(12) **EX PARTE REEXAMINATION CERTIFICATE** (11730th)
United States Patent
Thomas et al. (10) **Number:** **US 10,202,266 C1**
(45) **Certificate Issued:** ***Sep. 18, 2020**

| (54) | LOW PROFILE COMPACT TOOL CARRIERS | | <i>B66F 9/065</i> | (2006.01) |

EX PARTE REEXAMINATION CERTIFICATE

Fig. 2 of Dorkins

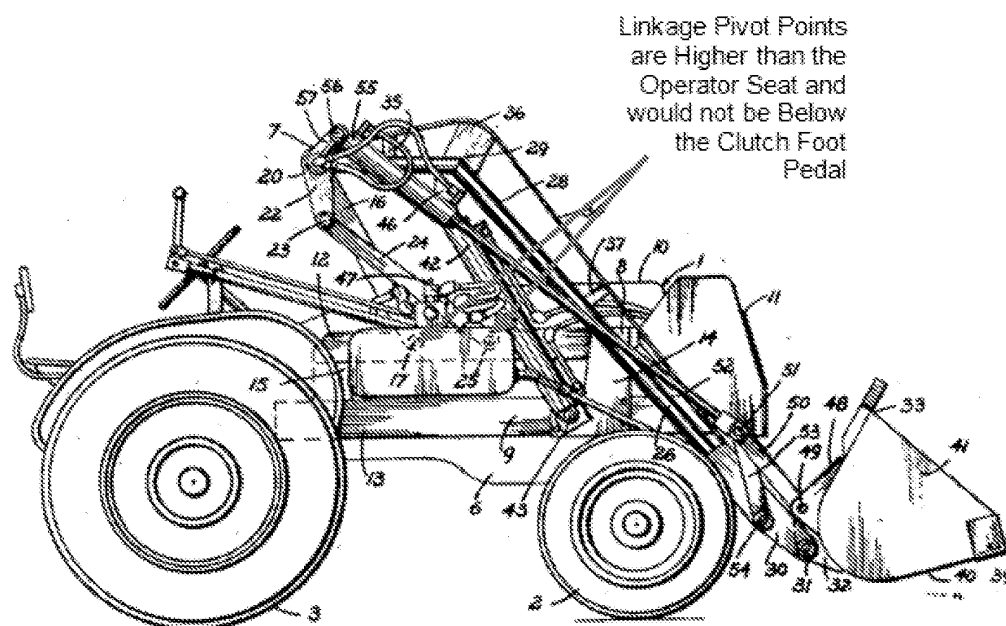
The operator controls for propelling the loader apparatus forward are not below the pivot points of the first and second linkages as required by claim 1. As noted in the October 18 response, the only control for propelling the loader forward shown in Dorkins is the clutch foot pedal shown in Figure 5³. It is evident that the pivot points 17, 25

between the first and second linkages 16, 24 and the support frame 8 of Dorkins would not be disposed below the clutch because the pivot points 17, 25 are so high that they are even *higher than the operator seat* as shown below.

Because the pivot points 17, 25 between the linkages 16, 24 and support frame 8 are not disposed below the operator controls for propelling the tractor forward (i.e., the clutch foot pedal), the Office has failed to establish that the prior art included each claimed element and the rejection must be withdrawn. MPEP §2143(I)(A).

Fig. 2 of Hoechst

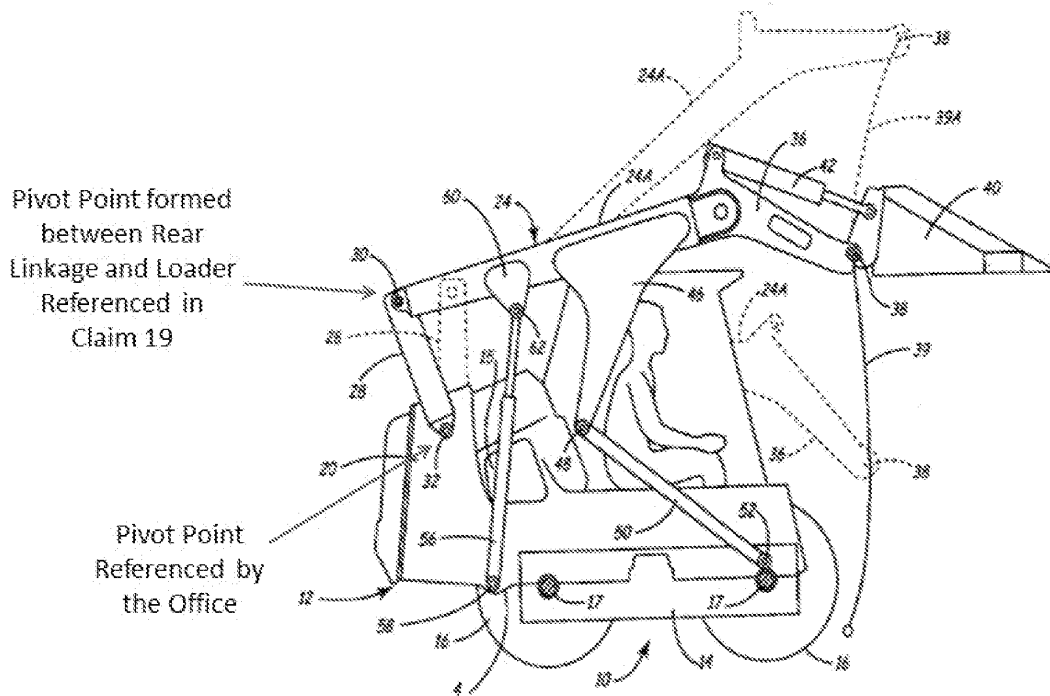
The Office references the pivot point formed between the rear linkage and *the mainframe* of Hoechst, not the pivot point formed between the rear linkage and *the loader* as recited in claim 19:

As shown in Figure 2 of Hoechst, the pivot point 30 formed in the loader is not (1) disposed within the barrier guard and/or (2) disposed forward of the barrier guard as the loader travels from the down position to the vertically raised position. This deficiency is not cured by Self which is cited by the Office to show standing or walk-behind operator control. Self discloses a radial lift loader, not a vertical-lift loader having first and second linkages attached to the mainframe and pivotally attached to the loader as recited in claim 19. Independent claim 19 is patentable over Hoechst in view of Self because neither Hoechst nor Self disclose a rear linkage connected to a loader at a pivot point which is (1) disposed within the barrier guard and/or (2) disposed forward of the barrier guard as the loader travels from the down position to the vertically raised position.

Figure G: Loader of Figure 7 of Komatsu on Dingo 322

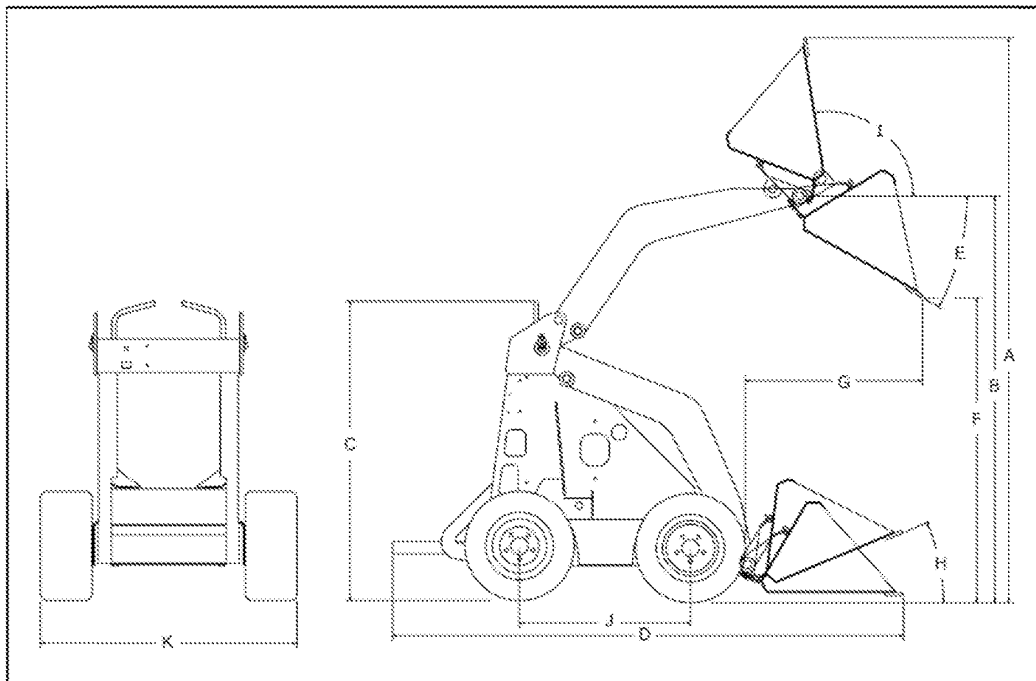
As shown in Figure G, use of the loader of Figure 7 of Komatsu on Dingo 322 results in a reach of only **9.6 inches** at full height with the bucket at a dump angle of 34°.

Modifying Dingo 322 by incorporating the embodiment of Figure 7 of Komatsu would render Dingo 322 unsuitable for its intended purpose because the modification would result in a reach of only 9.6 inches which **is 63% less** than the reach of Dingo 322.

Fig. 2 of Dorkins

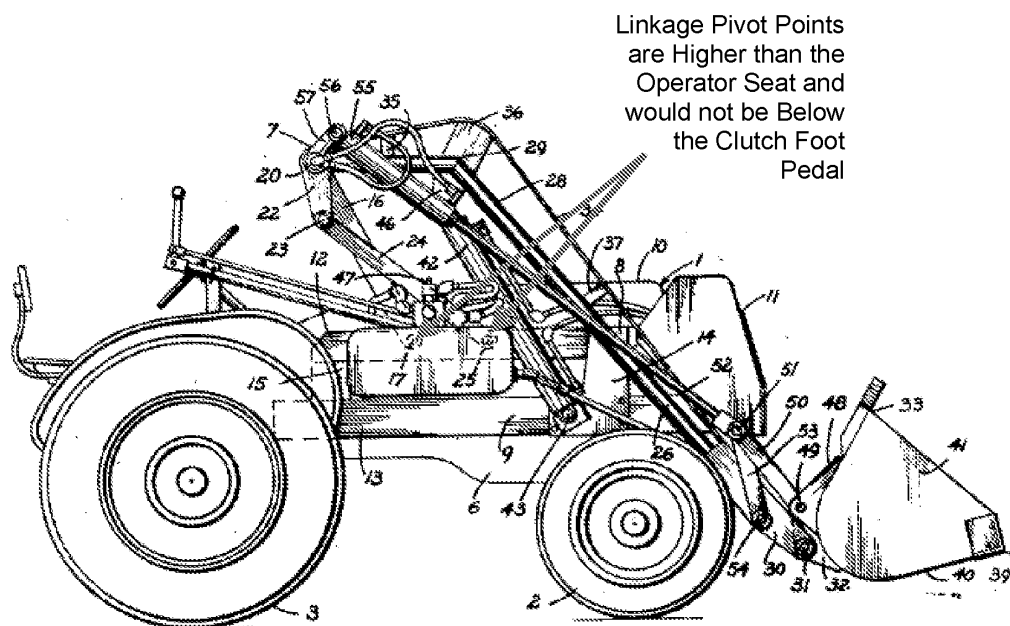
The only control for propelling the loader forward shown in Dorkins is the clutch foot pedal shown in Figure 5 (above). While the height of the clutch cannot be determined from Figure 5 of Dorkins because Figure 5 is a top view of the tractor, it is evident from Dorkins that the pivot points 17, 25 between the first and second linkages 16, 24 and the support frame 8 of Dorkins would not be disposed below the clutch as required by claim 1 of the '266 Patent. In particular, it is evident that the pivot points 17,

25 between the first and second linkages 16, 24 and the support frame 8 of Dorkins would not be disposed below the clutch because the pivot points 17, 25 are so high that they are even *higher than the operator seat* as shown below.

Because the pivot points 17, 25 between the linkages 16, 24 and support frame 8 are not disposed below the operator controls for propelling the tractor forward (i.e., the clutch foot pedal), the Office has failed to establish that the prior art included each claimed element and the rejection must be withdrawn. MPEP §2143(I)(A).

Figure 2B: Loading Profile of the Second Prototype

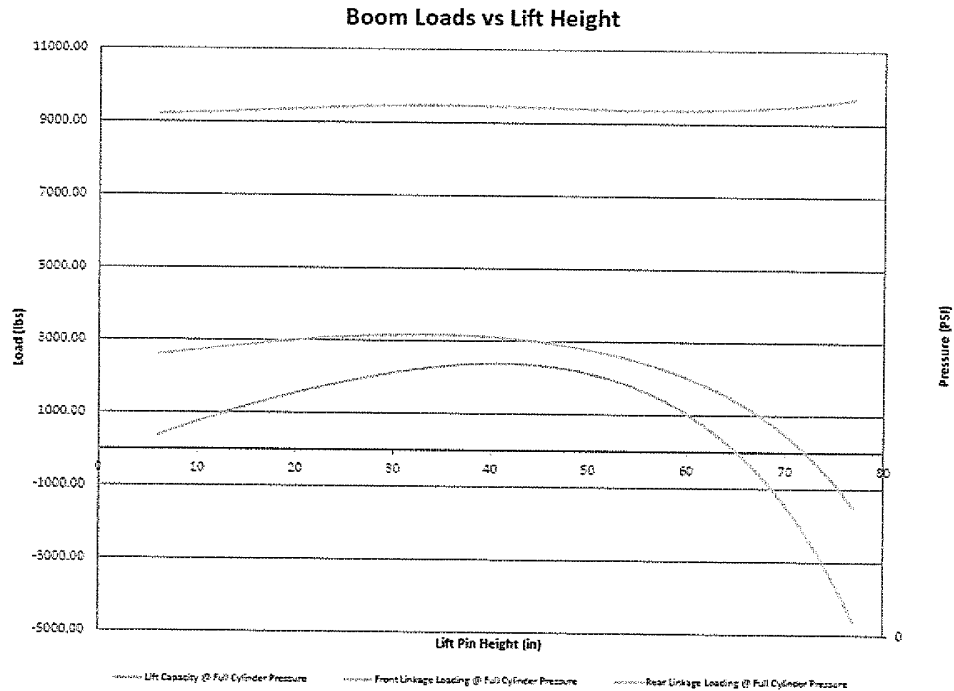
The linkages and actuators from the smaller initial prototype were scaled up for the second prototype. Scaling-up proved unsuccessful as shown in the lift profile of Figure 2B below.

As shown in Figure 2B, the second prototype would not be able to support a load during initial lifting and at its full extension as shown by the lift capacity curve (e.g., at less than about 5 inches of hinge pin height and beyond about 65 inches). Mathematical modeling and free-body diagram construction indicated that the second prototype would only be able to lift a load of 192 pounds when the loader was lifted from the supporting surface which is nearly insufficient to even lift the weight of the bucket when empty.

Figure 3A: Lift Profile of an Embodiment of the '266 Patent

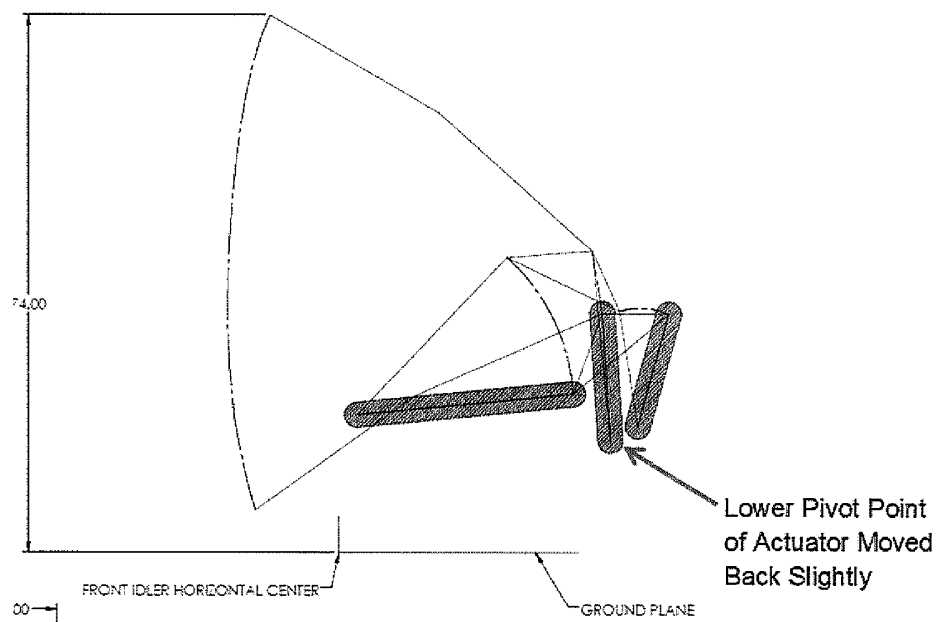
In a third prototype, the pivot point of the actuator in the loader support was moved **slightly rearward** as shown in Figure 3A:

Figure 3B: Loading Profile of Third Prototype

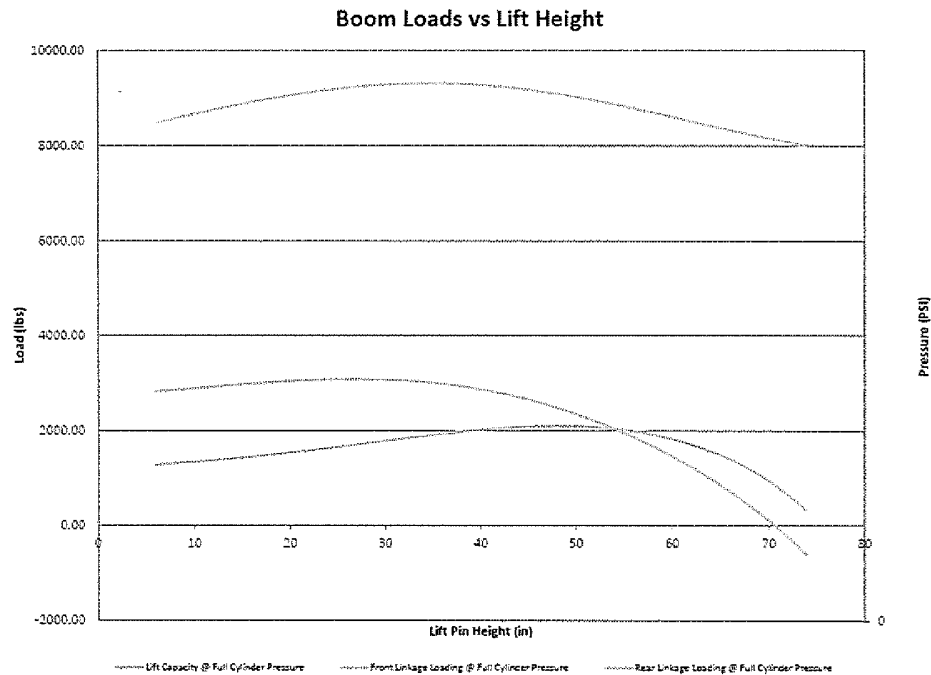
This resulted in a much improved loading profile shown in Figure 3B:

The lift profile of Figure 3A was incorporated into Vermeer's CTX50 commercial compact utility loader.

FIG. 2

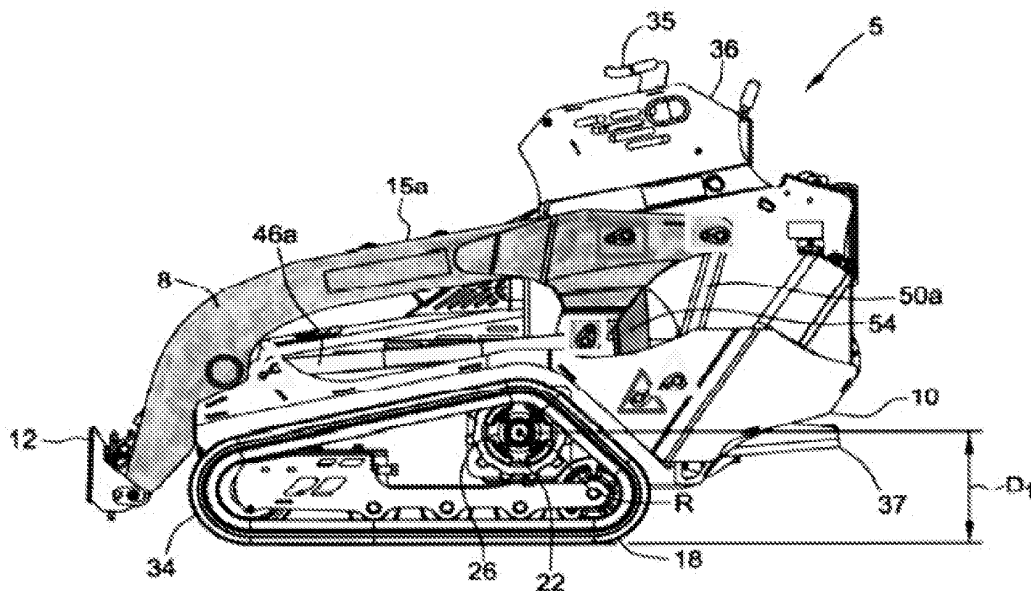
There are three components of the vertical lift linkage disclosed in the '266 patent, the two front and rear linkages colored yellow below and the hydraulic cylinder colored blue below. Each component has two pivots. The first pivot attaches the component to the loader arm colored green below. The second pivot attaches the component to the mainframe. Thus, there are six pivots in all. The three mainframe frame pivots have been enclosed in colored triangles corresponding to the color used for the component, two yellow triangles for the linkage to mainframe pivots and one blue triangle for the cylinder to mainframe pivot. The three loader arm pivots have been enclosed in similarly color coded boxes.

Claim 7 of the '266 patent purports to recite the vertical and fore-and-aft locations of these six pivots relative to certain landmarks. The relevant portion of claim 7 is reproduced below.

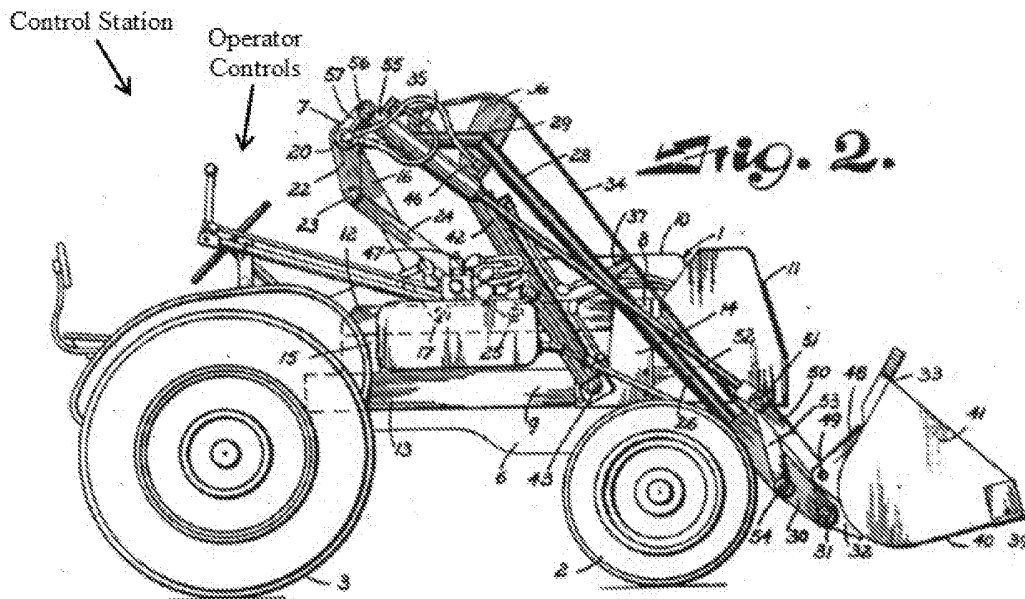
Fig. 2 of Dorkins is reproduced below and has been color coded similarly to that used with respect to the '266 patent, namely green for the loader arms, yellow for the front and rear linkages, and blue for the actuators. Dorkins' vertical lift linkage shown below comprises a green colored loader arm 26, a yellow colored linkage 24 and a yellow colored linkage 16 for movably supporting the green loader arm relative to a loader support 8, and a blue colored cylinder 42 for lifting and lowering loader arm 26. Fig. 2 of Dorkins below shows these vertical lift linkage components as placed on the right side of the tractor. Identical components not shown in Fig. 2 are contained on the left side of the tractor. A tool, namely bucket 41, is pivotally carried on the front ends of the left and right loader arms 26.

One relevant facet of Dorkins is the control station that is located at the rear of the tractor as Toro has labelled in the illustration of Dorkins above. This makes Dorkins applicable to many claims of the '266 patent which recite such a control station as being located "toward a rear of the loader apparatus". The control station of Dorkins clearly satisfies that criterion.

FIG. 2

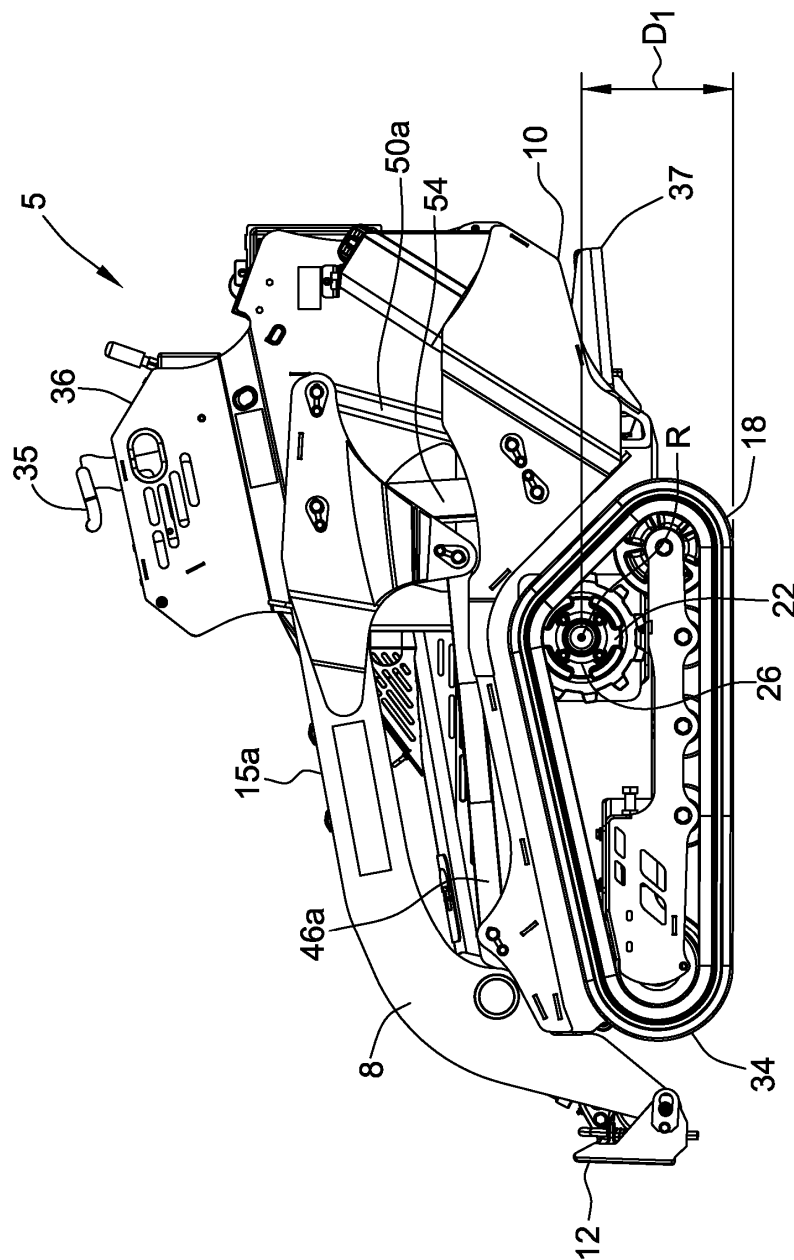
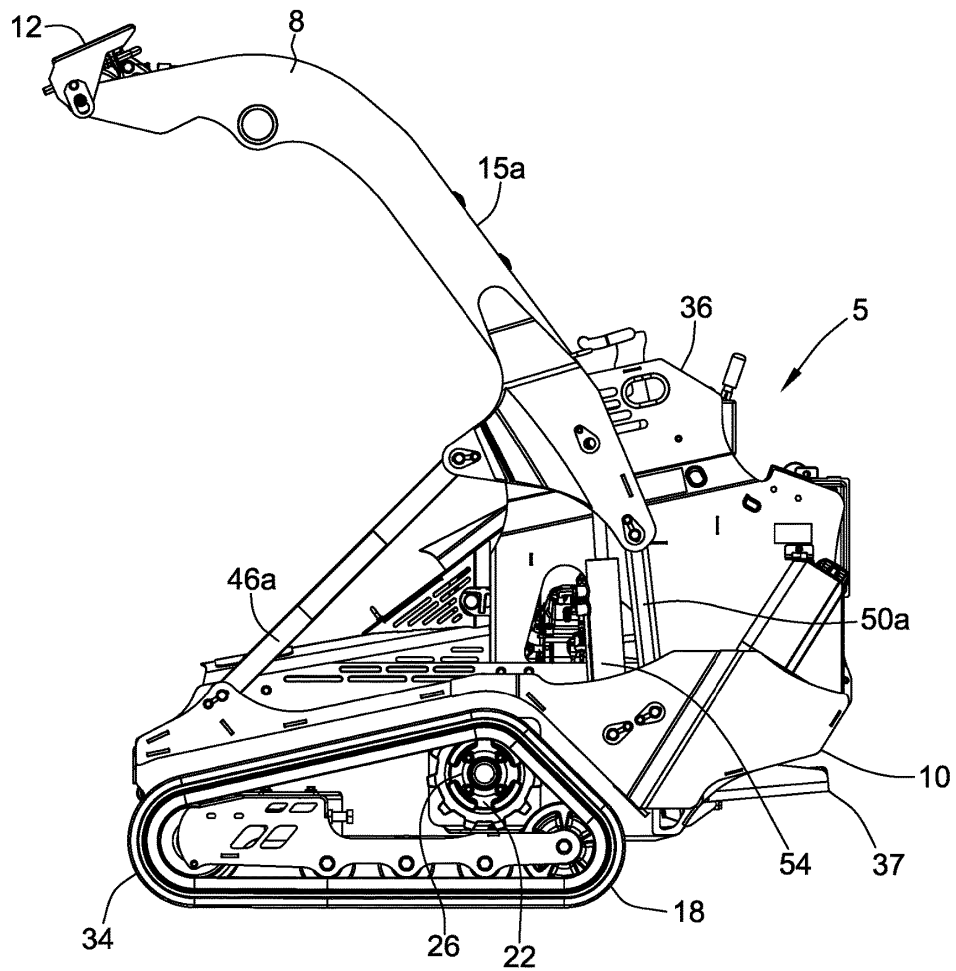
There is no disclosure in the subject '266 patent for the front linkage pivot point being disposed forward of the barrier guard (or for it to be disposed within *and* forward of the barrier guard) when the loader is in the down position. Figure 2 shows the forward linkage pivot point P4 to be squarely within the barrier guard as defined by the perimeter of the machine structure. There is no description in the patent for the pivot point P4 to be disposed anywhere else.

The patent further lacks description for the rear linkage pivot point to be forward of the barrier guard as the loader moves from the down position to the raised position as claimed. Figures 2 and 3 show the rear linkage pivot point P6 to always be disposed

Figure 2 shows the pivot point P4 to be within the machine structure perimeter.

The drawings further do not show the rear linkage pivot point disposed forward of the machine structure perimeter. Figures 2 and 3 show the pivot point P6 to always be disposed within the machine structure perimeter.

The drawings further do not show the actuator pivot point disposed forward of the machine structure perimeter. Figures 2 and 3 show the pivot point P5 to always be disposed within the machine structure perimeter.

The Response asserts support for claim 37 in column 3, lines 64-66, but support for the noted subject matter is not present. Figures 2 and 3 do not support the noted claim language.

The drawings do not show the actuator pivot point disposed forward of the machine structure perimeter. Figures 2 and 3 show the pivot point P5 to always be disposed within the machine structure perimeter.

Unfortunately, the drawings of the '266 (namely figures 2 and 3) do not provide sufficient detail to suggest that the perimeter of the machine forms a "barrier guard" as it would be understood by those of ordinary skill in the art.

PO asserts that figures 2 and 3 of the '266 patent provide sufficient detail to show possession of the "barrier guard." The figures of the patents do not show the "barrier guard" as now defined. The entire perimeter of the machine is not shown in the drawings as evidenced by PO's inability to trace a complete outline around the portion

of the machine now argued to be a "barrier guard." See marked-up figures 2 and 3 on page 31 of the Remarks. Yet PO wishes to base the definition of the claimed "barrier guard" on the incomplete perimeter. How could one of ordinary skill in the art avoid infringing the claim when the "barrier guard" is defined as a projection of a profile onto a plane when the profile is not even shown?

The Office concedes that Figures 2 and 3 show a portion of the perimeter of the machine structure as defined by the mainframe and upper frame but objects that the entire perimeter is not shown (pages 28-29 of the Office action) (Figures 2 and 3 as submitted in the October 18, 2019 response being reproduced below).

The fact that the lower portion of the perimeter of the mainframe is not shown in Figures 2 and 3 does not negate the understanding of one of skill in the art that the mainframe and upper frame have a perimeter⁵. **Figures 2 and 3 show the pivot points formed in the loader and their relation to the perimeter of the machine structure defined by the mainframe and upper frame** as recited in claim 19. Accordingly, claim 19 and claims depending therefrom are entitled to the February 20, 2015 priority date. The Ramrod Brochure is dated October 2016 which is *after* the February 20, 2015 priority date of the ‘266 Patent and, accordingly, the Ramrod Brochure is not prior art against claims 19-23.
